May 15, 2019

RE: Fire Station #9
Conceptual Grading and Drainage Plan and Drainage Report
Engineer's Stamp Date: 05/02/2019
Hydrology File: H20D043

AFD FIRE STATION 9

C-100

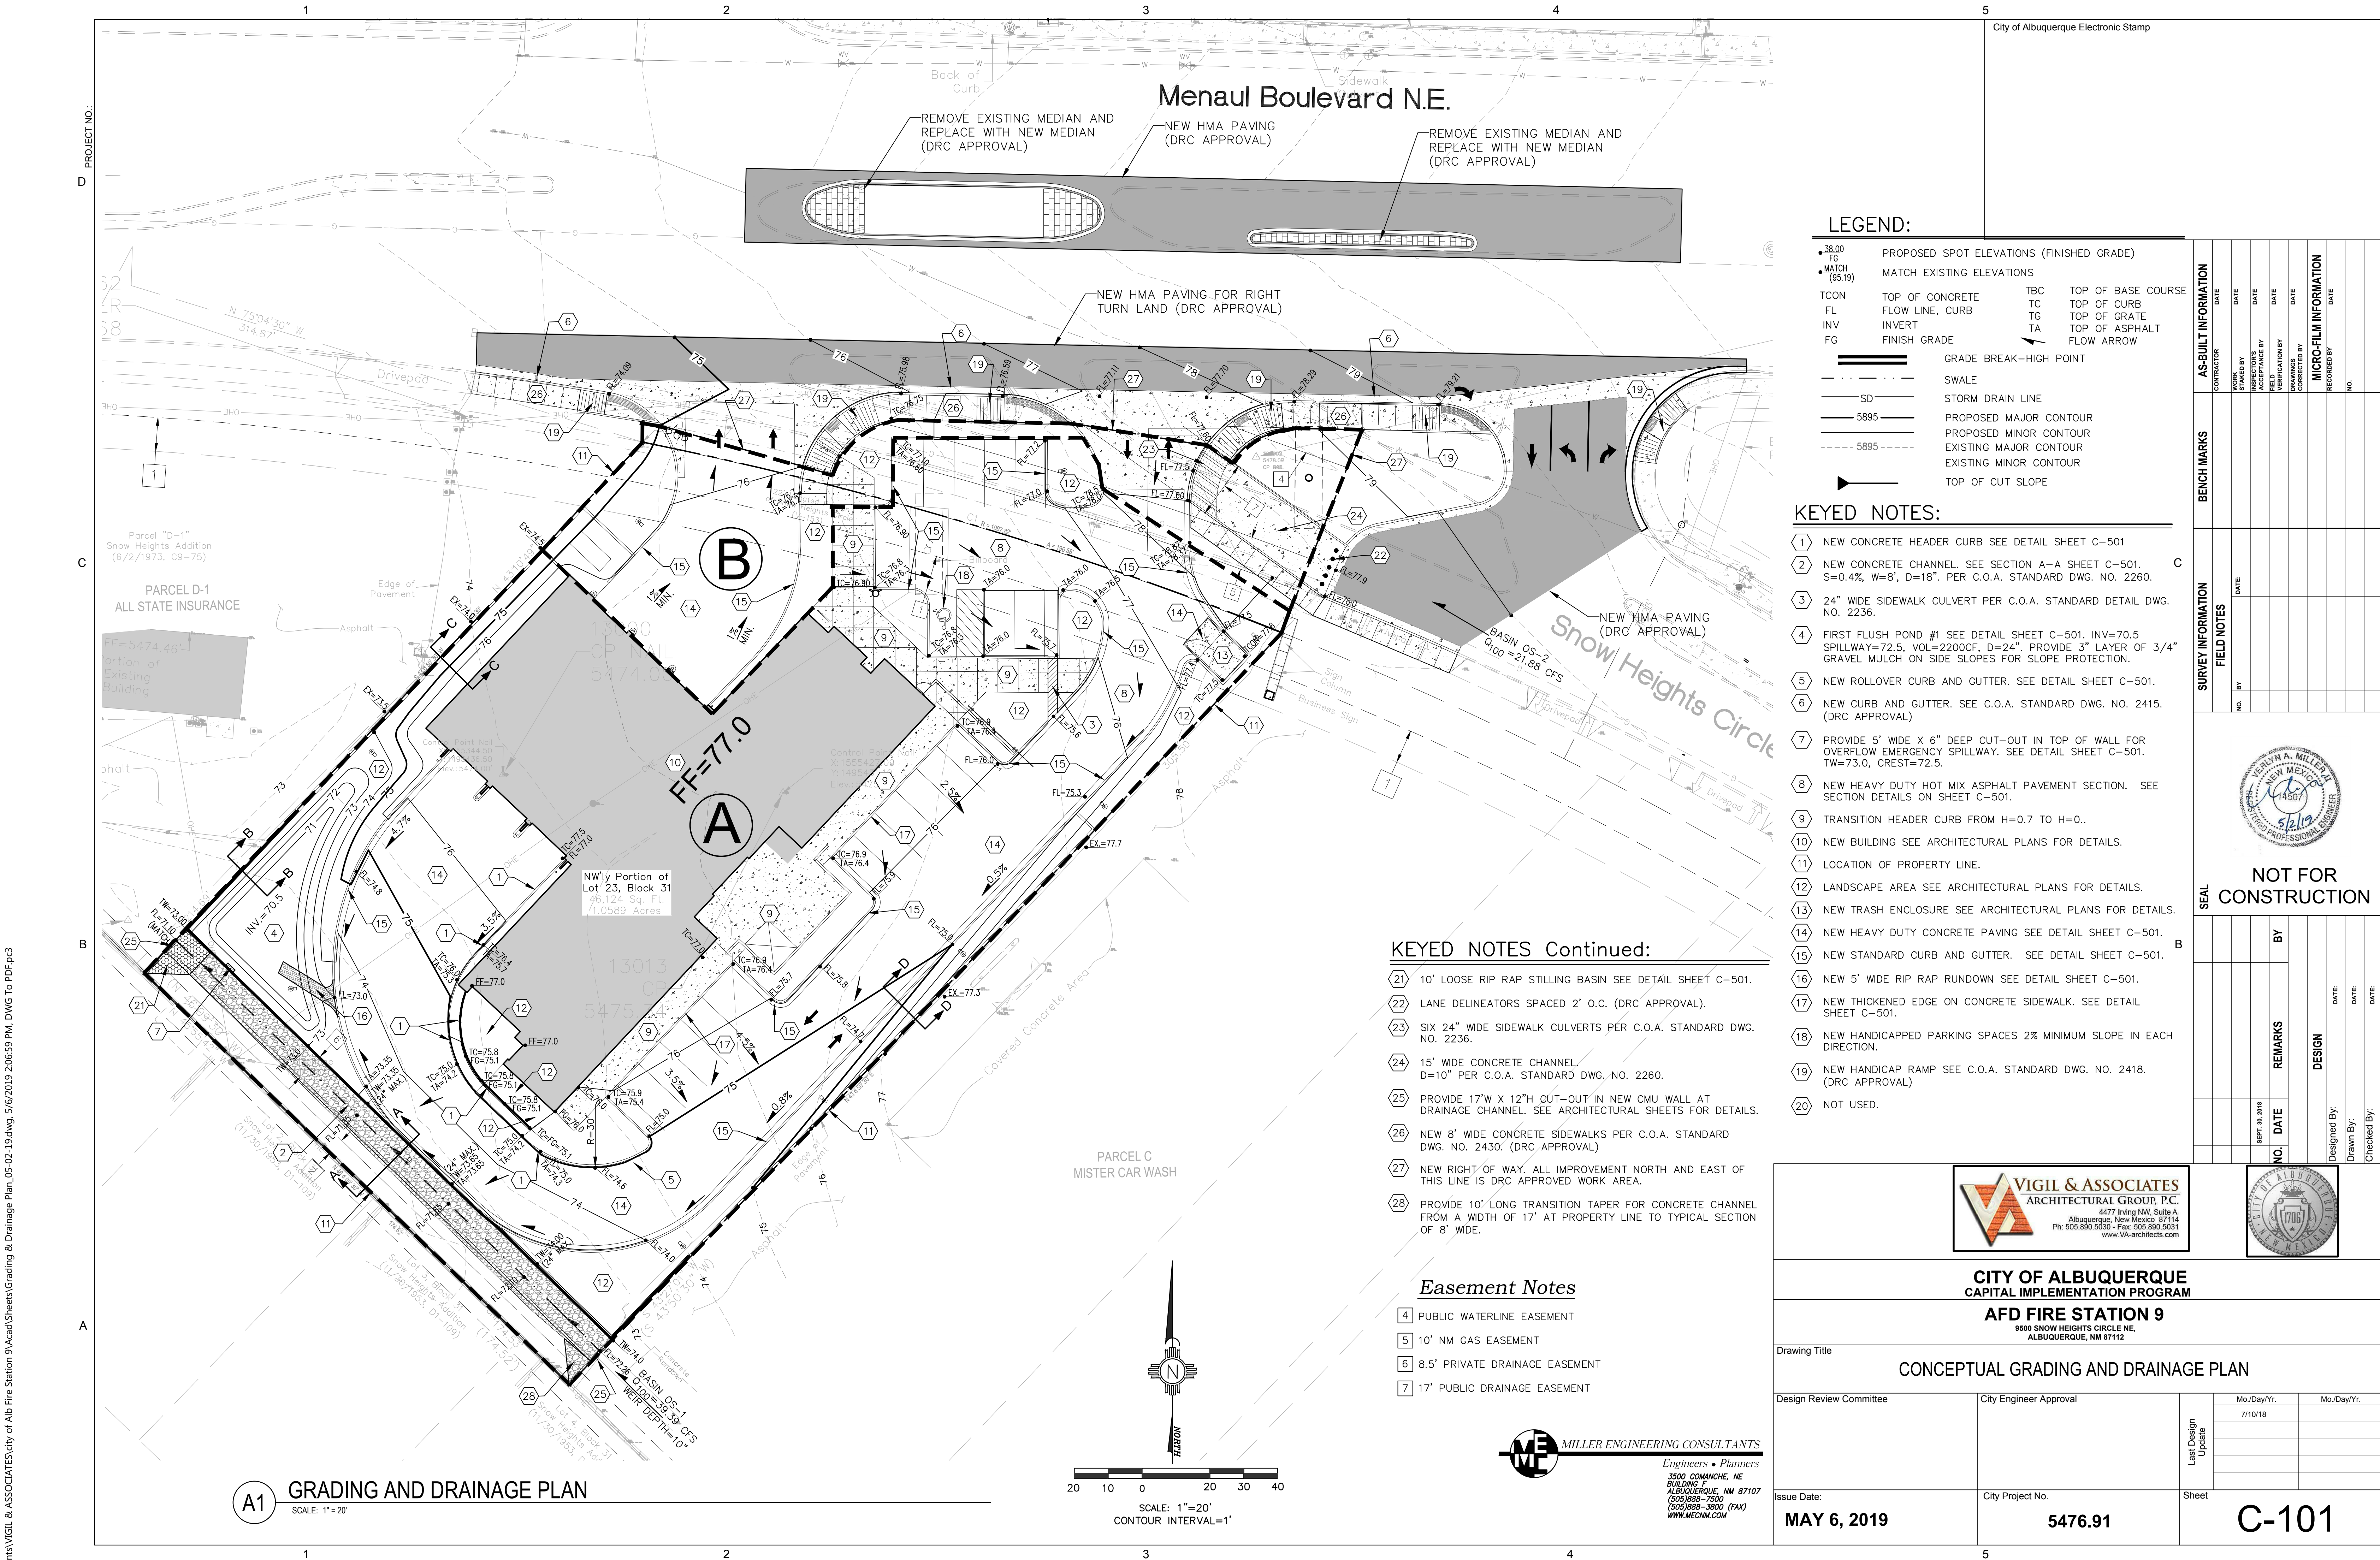
As a condition of approval, written permission is required from neighbors prior to the encroachment of any new wall, wall footer, or removal of any existing walls or fences on those adjacent properties. If permission is not obtained then keep all improvements including footers off of the neighbor's property.

Also as a condition of approval additional spot elevations will be required on the WO plans to demonstrate a water block on the east driveway that is a minimum of 0.87' measured perpendicular to the flow.
